**NAVFAC SPECIFICATION
08-1428**

AMENDMENT NO. 0003

14. DESCRIPTION OF AMENDMENT/MODIFICATION (Organized by UCF section headings, including solicitation/contract subject matter where feasible.) P1227,BEQ WOUNDED WARRIOR BATTALION, MCB, CAMP LEJEUNE, NORTH CAROLINA RECEIPT OF PROPOSALS REMAINS 7 NOVEMBER 2008 @ 2:00 PM NO MORE BID INQUIRIES WILL BE RECEIVED. SEE CONTINUATION SHEET sharon.taylor@navy.mil					
Except as provided herein, all terms and conditions of the document referenced in Item 9A or 10A, as heretofore changed, remains unchanged and in full force and effect.					
15A. NAME AND TITLE OF SIGNER (Type or print)			16A. NAME AND TITLE OF CONTRACTING OFFICER (Type or print)		
			TEL: _____ EMAIL: _____		
15B. CONTRACTOR/OFFEROR _____ (Signature of person authorized to sign)	15C. DATE SIGNED	16B. UNITED STATES OF AMERICA BY _____ (Signature of Contracting Officer)		16C. DATE SIGNED 28-Oct-2008

AMENDMENT 0003

ELECTRICAL LIGHTING - FIRST FLOOR PLAN

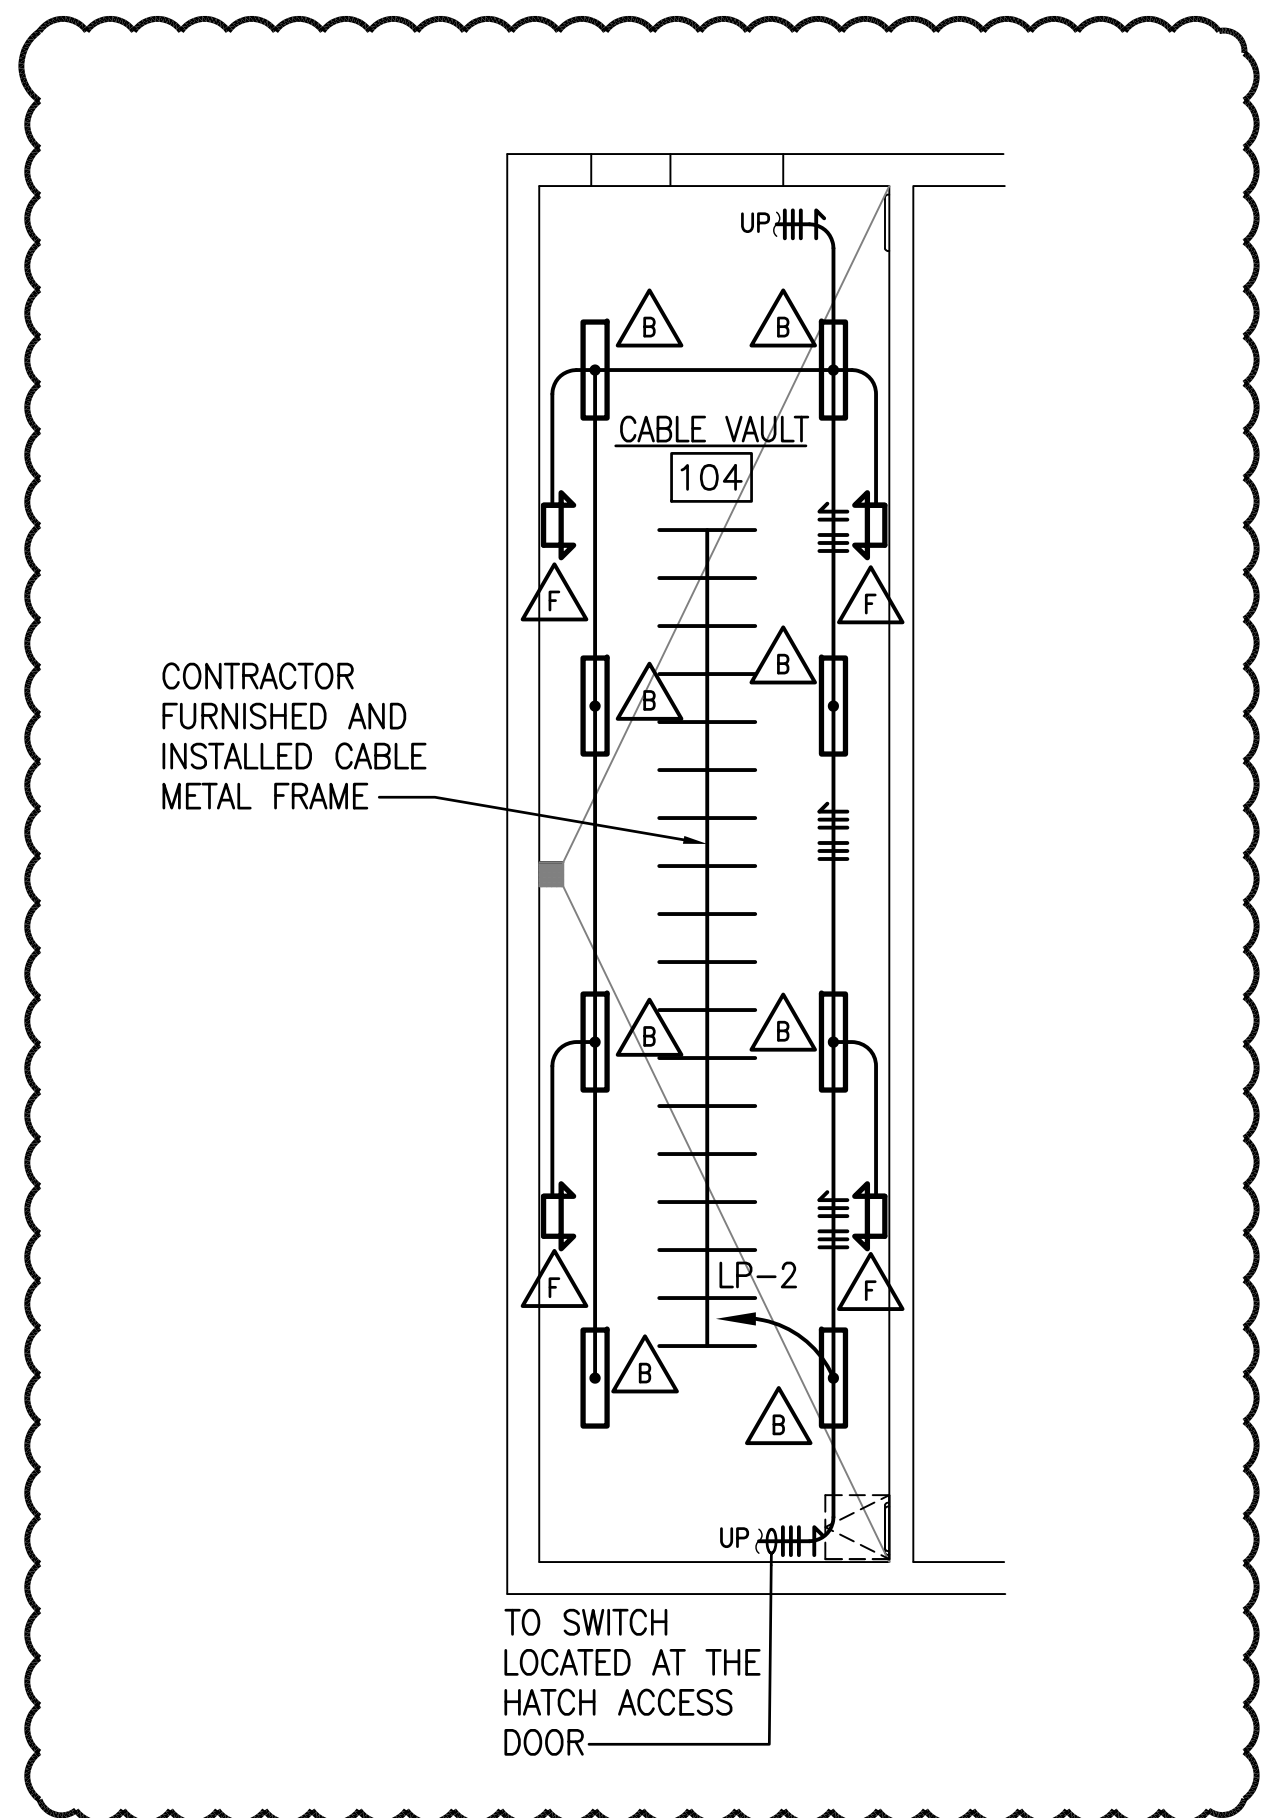
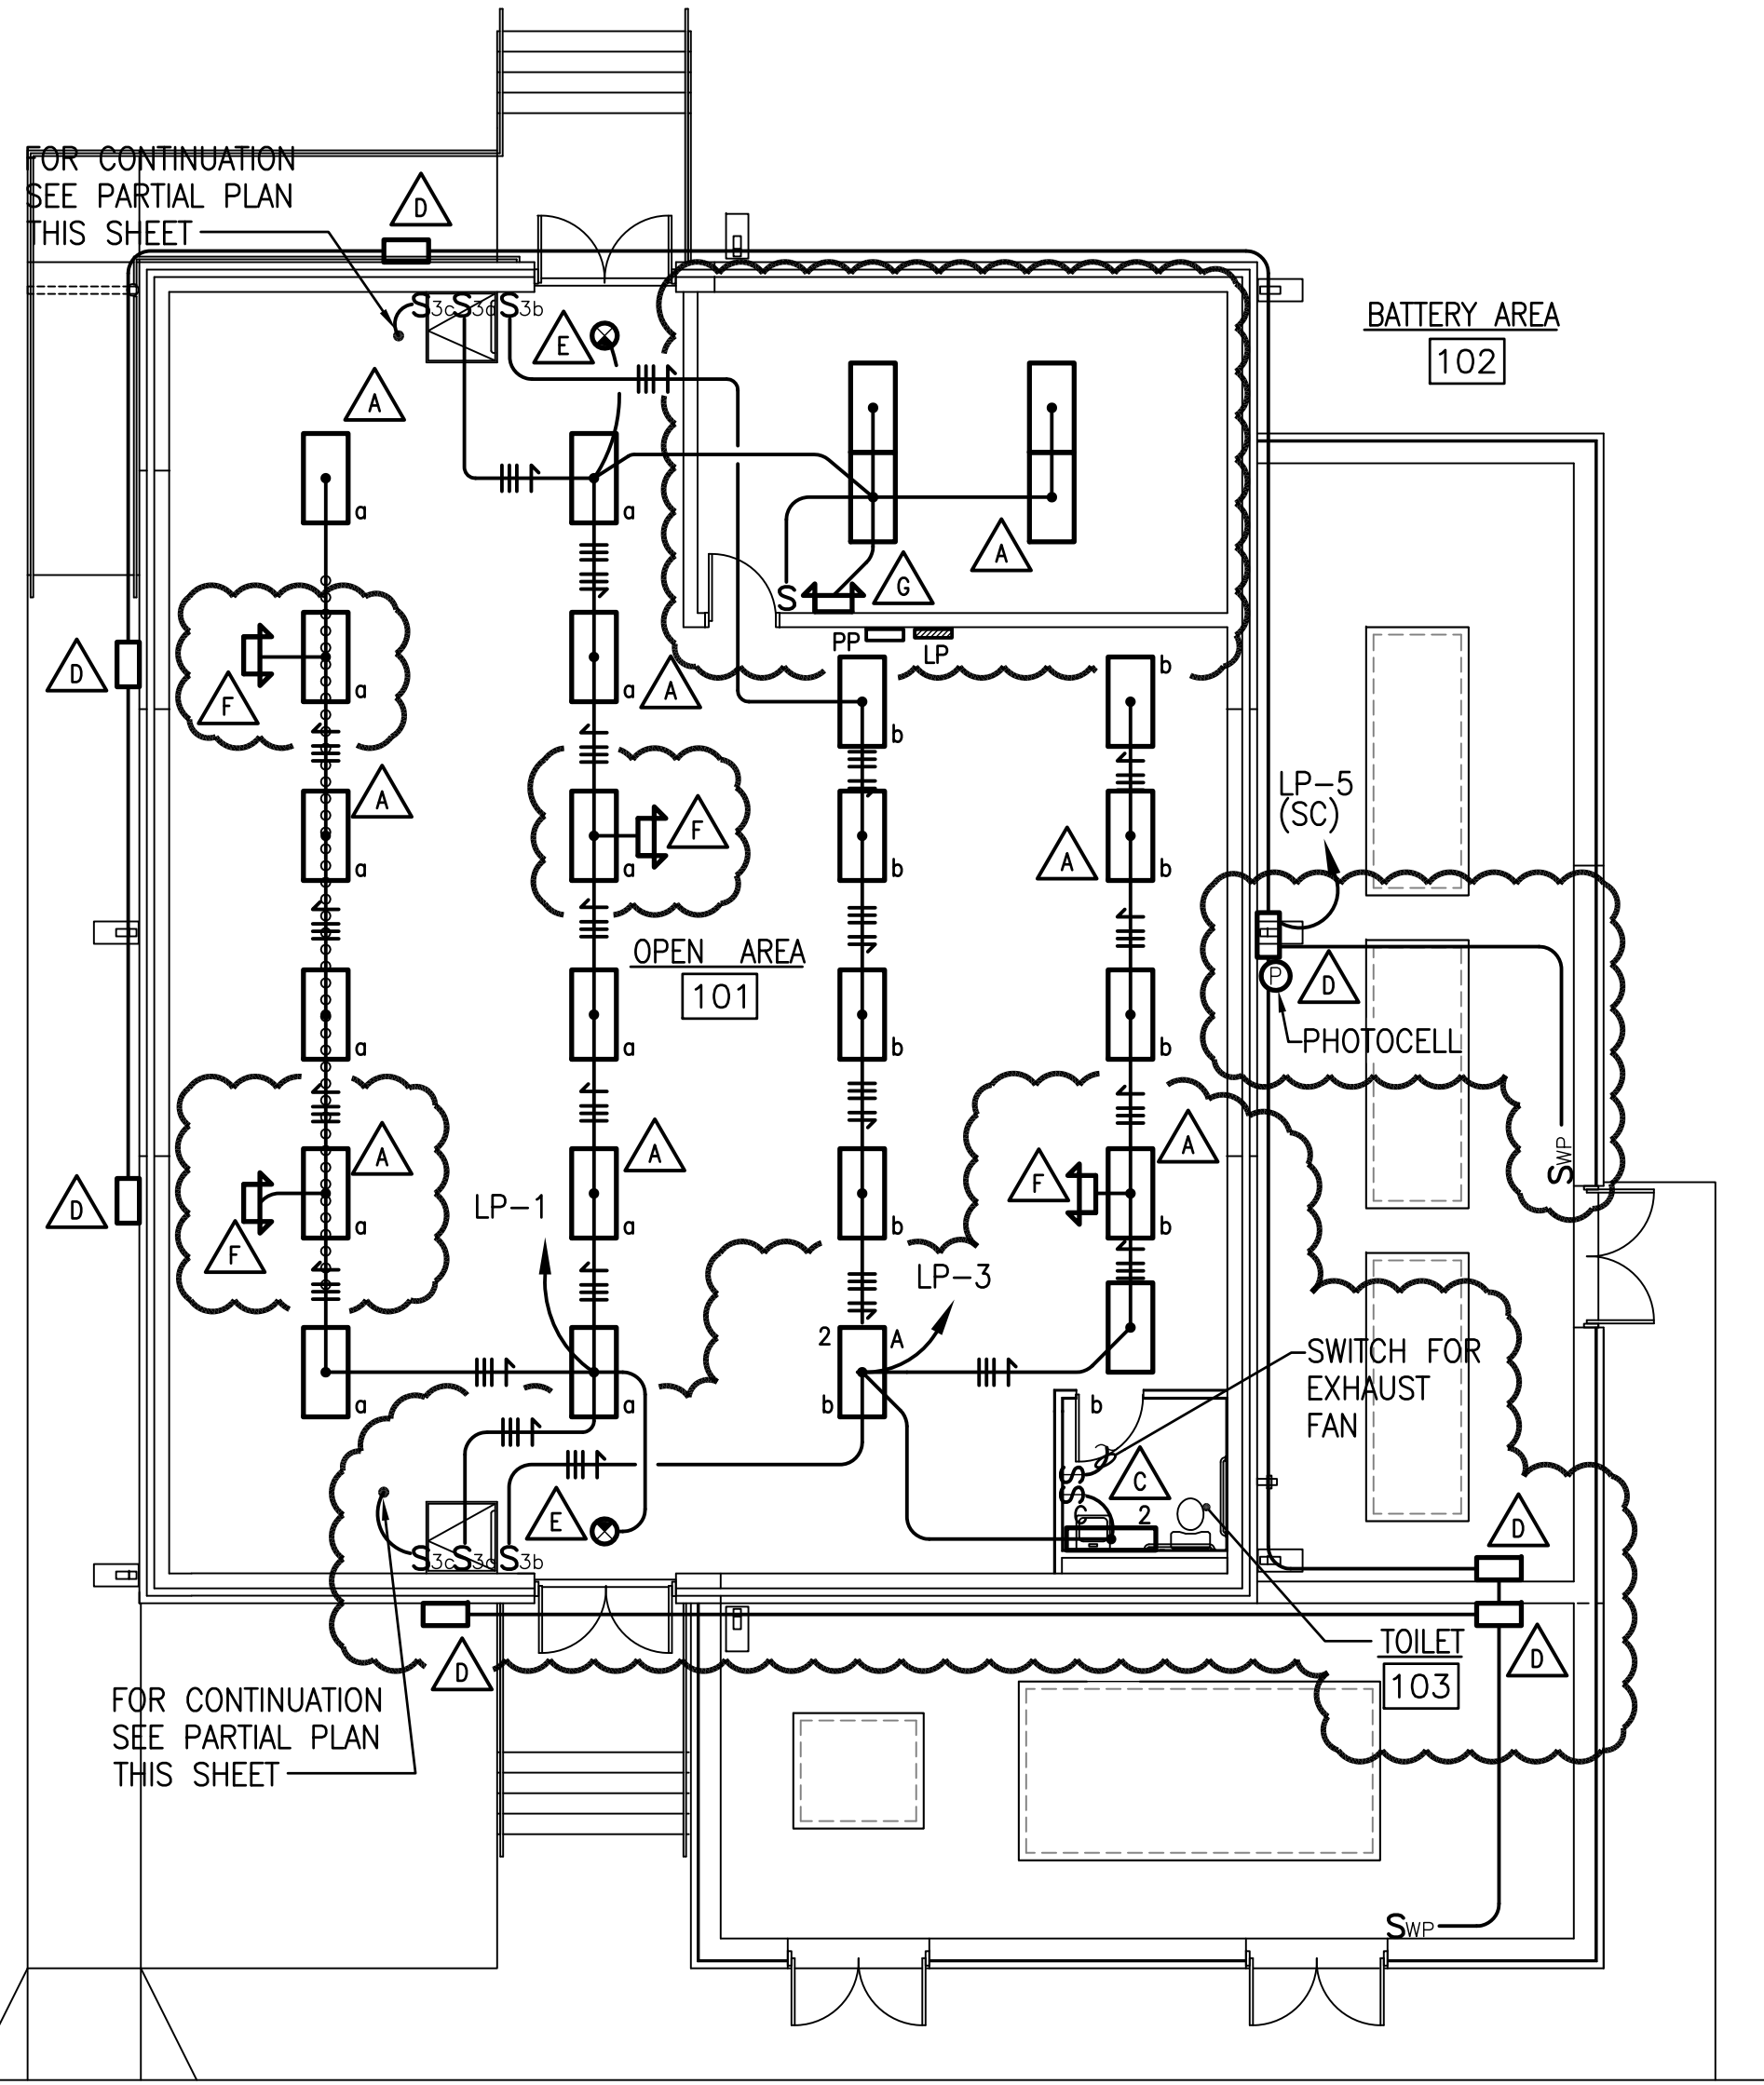
12525248	Electrical Power – First Floor Plan, Revised
12525249	Electrical Lighting – First Floor Plan, Revised
12525253	Electrical Power – Single Line Diagram, Revised
12525254	Telecommunications – Single Line Diagram, Revised

ELECTRICAL POWER - SINGLE LINE DIAGRAM
NOT TO SCALE

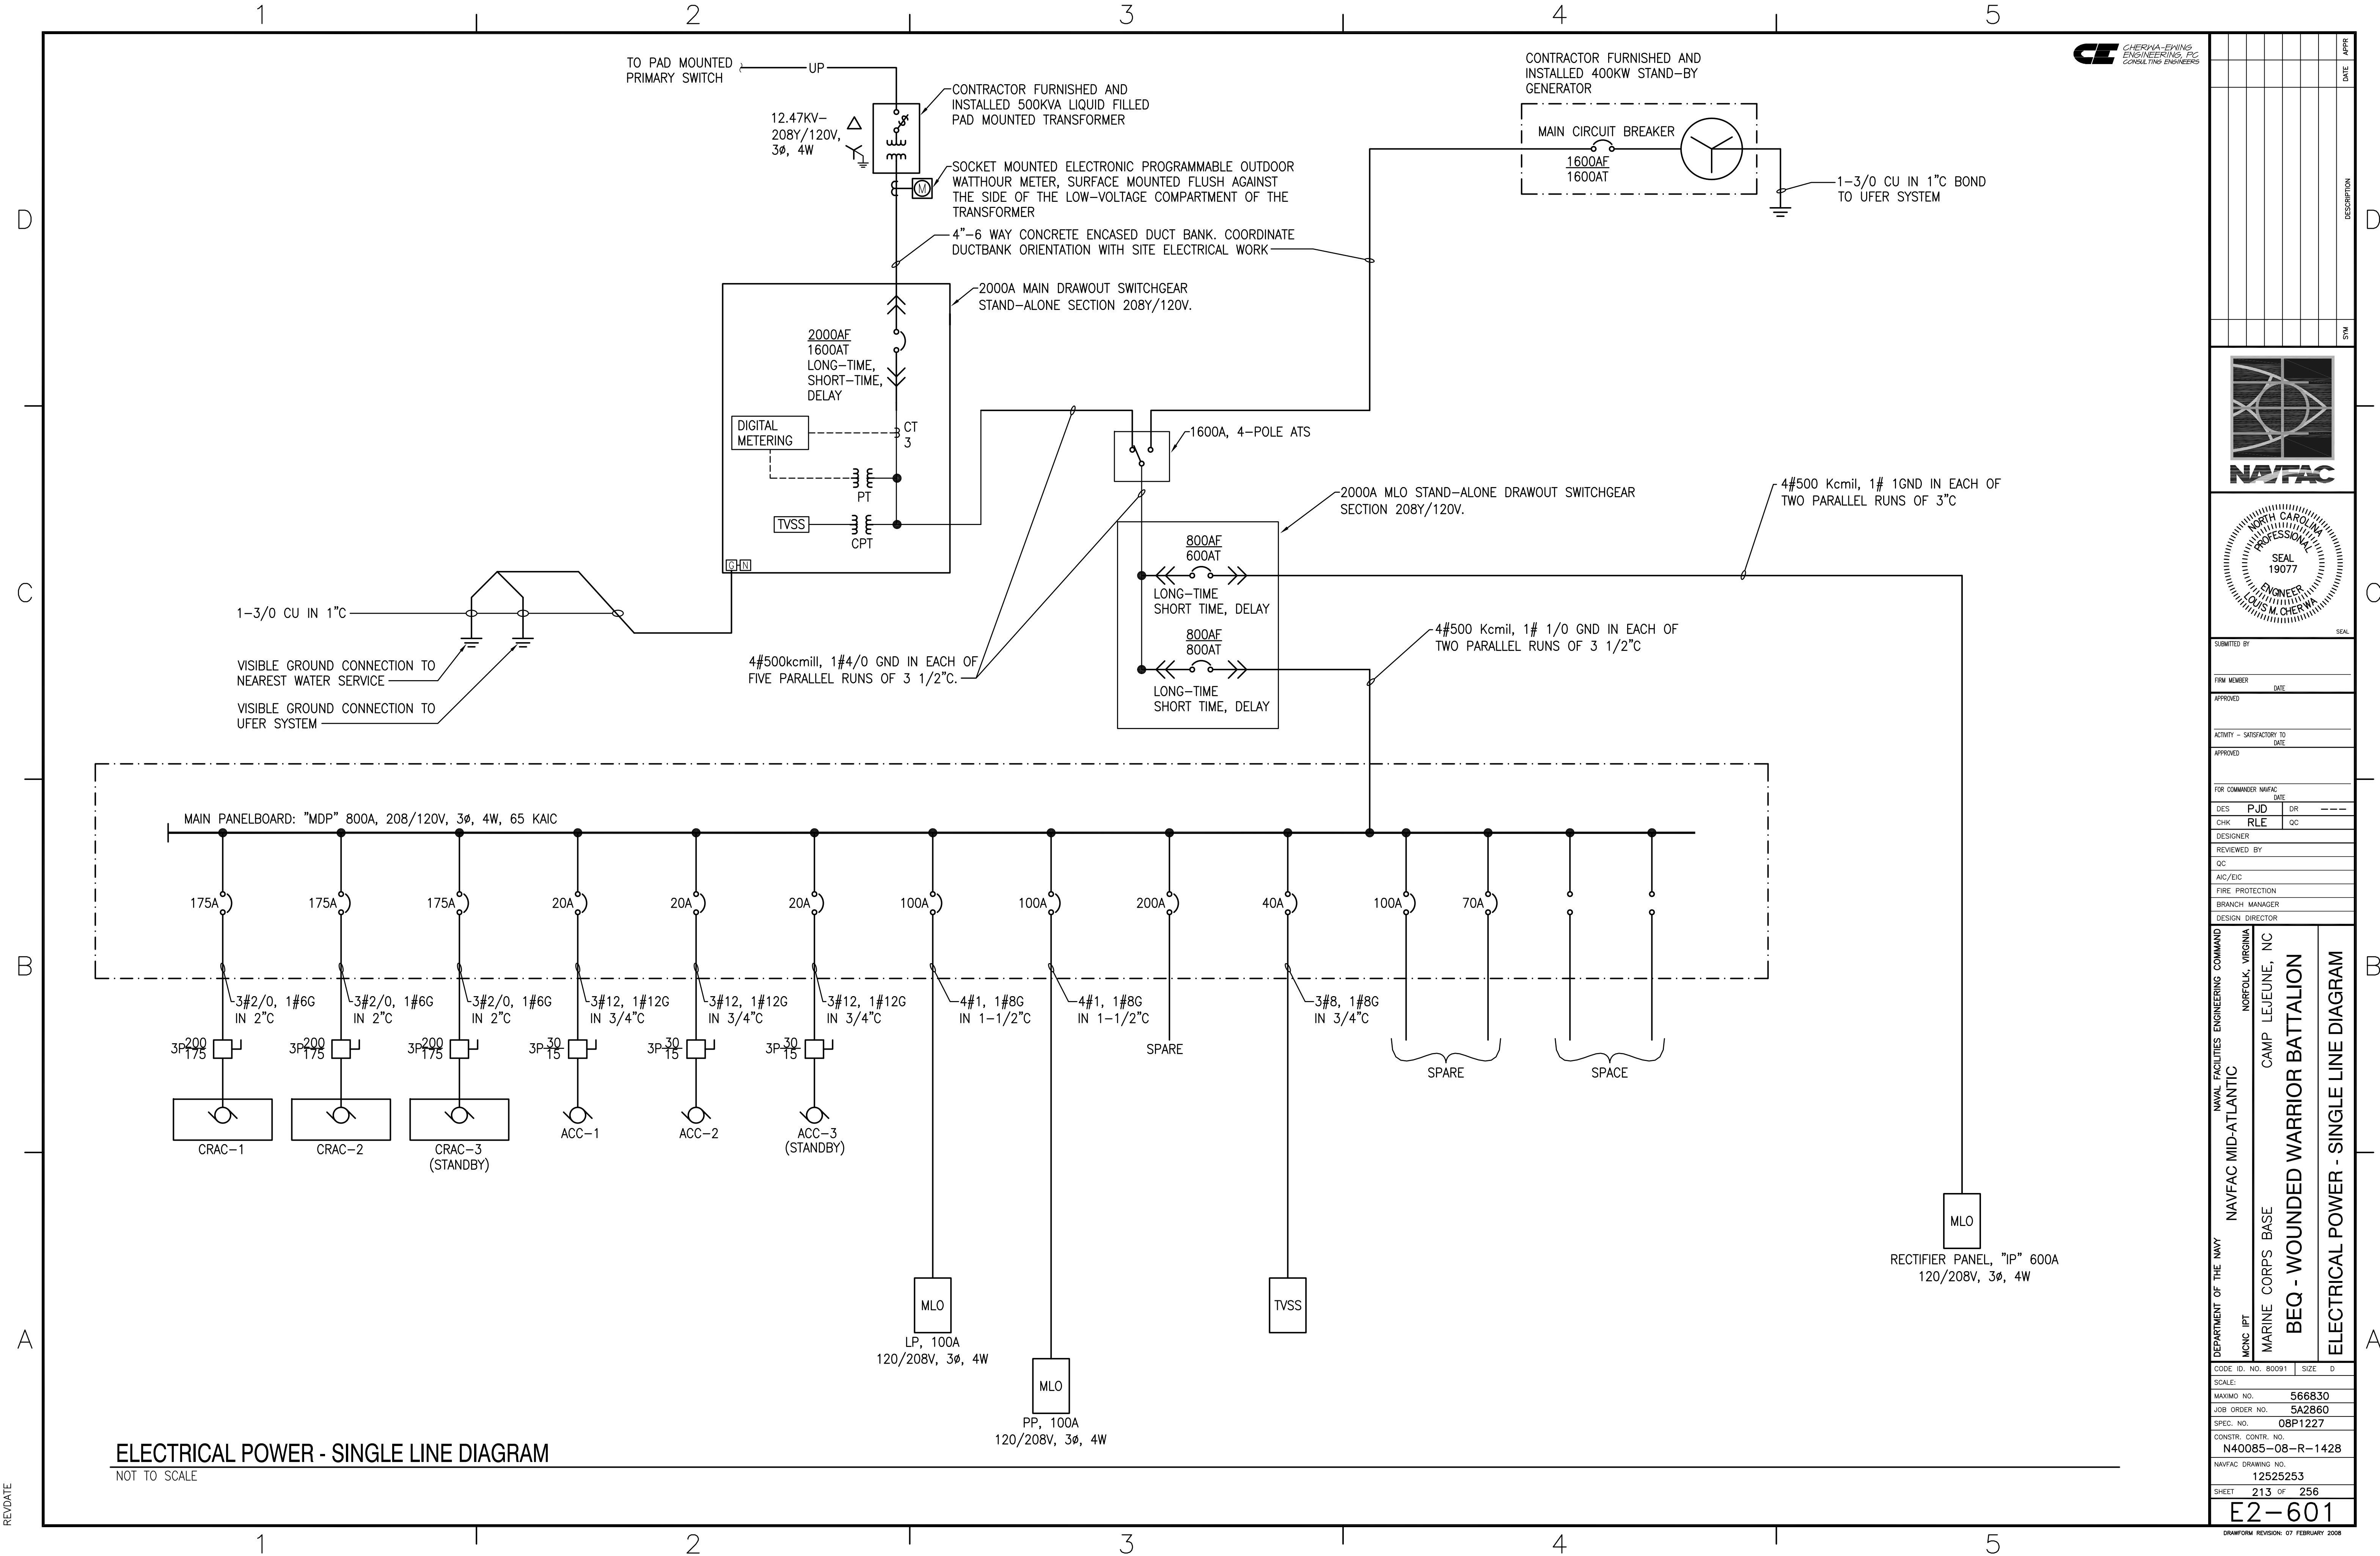
b.9. Change CT ratio from “800/5” to “1200/5, RF to 1.5”.

Change Panel MDP to 800A MLO panel, delete 600A/3P breaker to Panel RP make a 200A/3P spare. Add 20A/2P circuit breaker to Panel ‘PP’; space 40, 42; for DCU.

HVAC EQUIPMENT MOUNTING PLAN

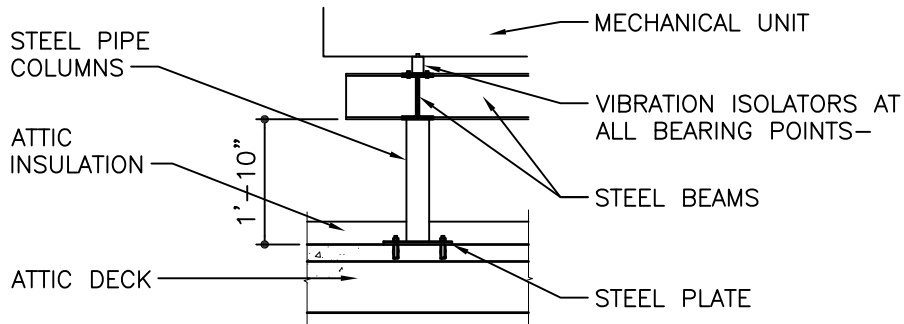
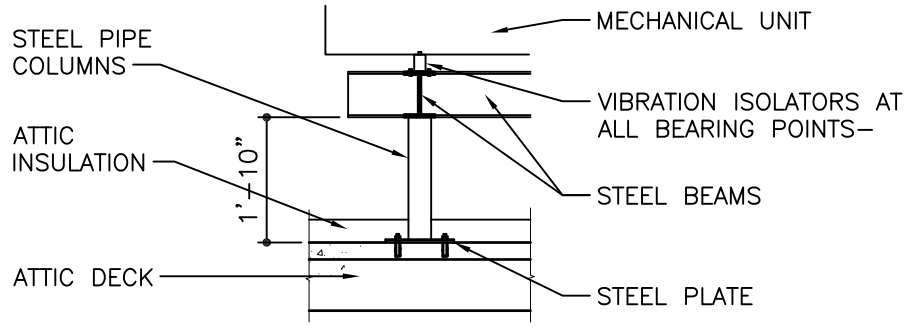
19. Steel SubFrame at Mechanical Units - Note 6 on S1-105 indicates that “Mechanical Units shall be supported from or suspended from a minimum of 3 joist and at panel points only. Provide steel sub framing if required.” It is intended that major mechanical equipment is to be placed on the attic slab with the required vibration isolation. Please clarify if the mechanical units can be placed on the attic slab. If this cannot occur, please provide the framing design since this is a structural element and not a miscellaneous steel item. Other than hollow core design, we do not have design requirements for this building.

RESPONSE: See sketch SKA1-006 which accompanies this amendment.
